Access Compliance Report

Public Rights-of-Way

(Curb Ramps)

Intersection ID: 12310	Main Street: WEYLAND_AV	Cross Street: GREENLAND_AV	Location: NE
ADA ID: 26535A25DEE4	Ramp Type: PerpDiag	Initial Pass/Fail: Fail	Overall Compliance: No
Severity Score: 22.5			
Codes/Mitigation Info/Possible Solution		Field Measurements/Component Compliance

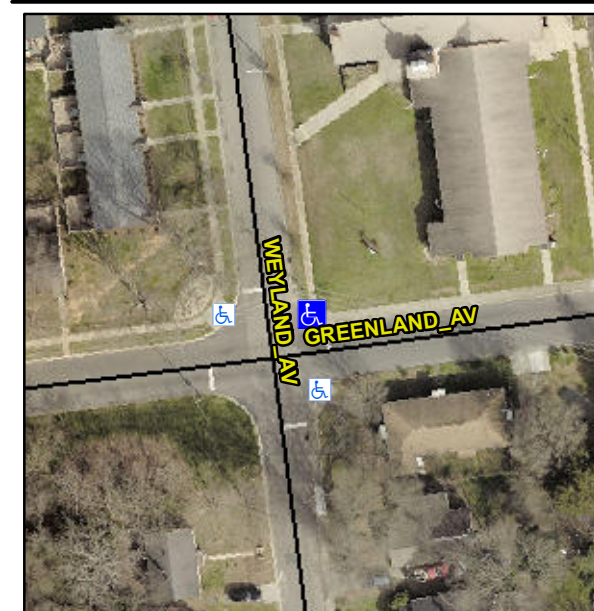
Not Found, R304.5.1, R304.2.2, R304.5.3

Compliance	Description	Data	Compliance	Description	Data
N/A	Ramp Length (in)	62.0	No	Ramp Slope (%)	8.6
No	Ramp Width (in)	38.5	No	Ramp XSlope (%)	3.0
N/A	Flare Type LT	N/A	N/A	Flare Type RT	N/A
N/A	Flare Slope LT (%)	N/A	N/A	Flare Slope RT (%)	N/A
N/A	Flare Traversable LT?	N/A	N/A	Flare Traversable RT?	N/A
N/A	Landing Length (in)	N/A	N/A	DWS Provided?	N/A
N/A	Landing Width (in)	N/A	N/A	DWS Contrast?	N/A
N/A	Landing Slope (%)	N/A	N/A	DWS Length (in)	N/A
N/A	Landing X Slope (%)	N/A	N/A	DWS Full Width?	N/A
N/A	Landing Curb? (Y/N)	N/A	N/A	DWS Offset (in)	N/A
N/A	Shared Landing?	N/A			
N/A	Gutter Ponding?	N/A	N/A	Gutter Slope (%)	N/A
N/A	Gutter Lip Ht (in)	N/A	N/A	Gutter X Slope (%)	N/A
N/A	Painted X Walk1?	No	N/A	Painted X Walk2?	No
	X Walk 1 Direction	To W		X Walk 2 Direction	To S
N/A	X Walk 1 Width (in)	N/A	N/A	X Walk 2 Width (in)	N/A
	X Walk 1 Slope (%)	2.5		X Walk 2 Slope (%)	0.7
	X Walk 1 X Slope (%)	0.5		X Walk 2 X Slope (%)	2.2

Remove & Replace Curb Ramp With Two New Directional Ramps or Equivalent.
